Southern Nuclear Operating Company
Vogtle Electric Generating Plant Units 3 and 4
Request for License Amendment and Exemption:
Fire Protection System Non-Safety Cable Spray Removal (LAR-18-015)

**Request for License Amendment Regarding
Fire Protection System Non-Safety Cable Spray Removal
(LAR-18-015)**

Proposed Changes to Licensing Basis Documents

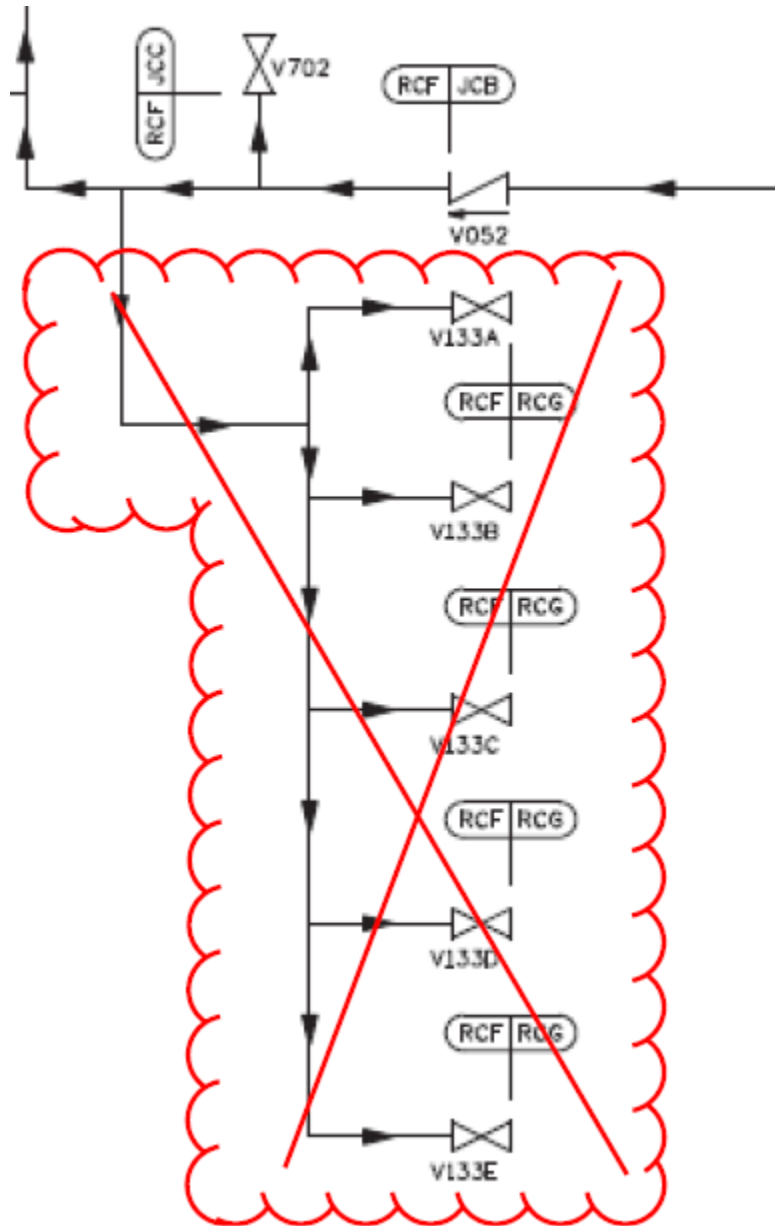
1. COL Appendix C (and corresponding plant-specific Tier 1), Figure 2.3.4-1, sheet 2 – Remove depiction of containment water spray piping to fire zone 1100 AF 11300B
2. COL Appendix C (and corresponding plant-specific Tier 1), Figure 2.3.4-2 - Remove depiction of containment water spray piping to valves V133A/B/C/D/E
3. UFSAR Table 9.5.1-3 – Remove exception to NFPA 15 Section 5.7.2.1 that requires all actuation valves be listed as the non-listed valves are no longer being used.

Revise COL Appendix C (and corresponding plant-specific Tier 1) Figure 2.3.4-1, sheet 2 to remove the depiction of containment water spray piping to fire zone 1100 AF 11300B (shown in bubble) as shown below:

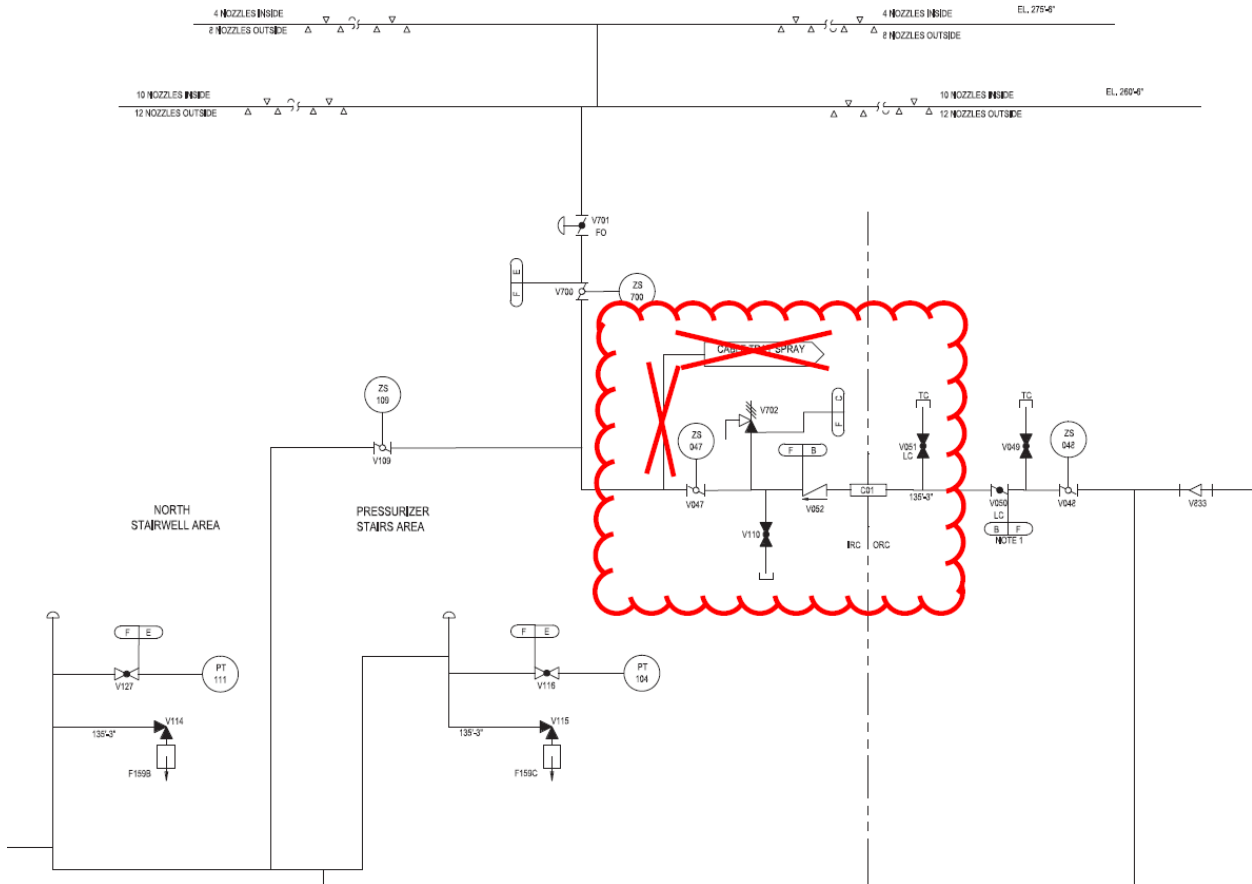
4. UFSAR Figure 9.5.1-1, sheet 3 – Remove depiction of branch line for Cable Tray Spray.
5. UFSAR Subsection 9A.3.1.1 – Delete fourth bullet (Water spray systems in specific locations) under "Fire Detection and Suppression Features."

Revise Updated Final Safety Analysis Report (UFSAR) Figure 9.5.1-1, sheet 3, to remove the depiction of the branch line for cable tray spray as shown below:
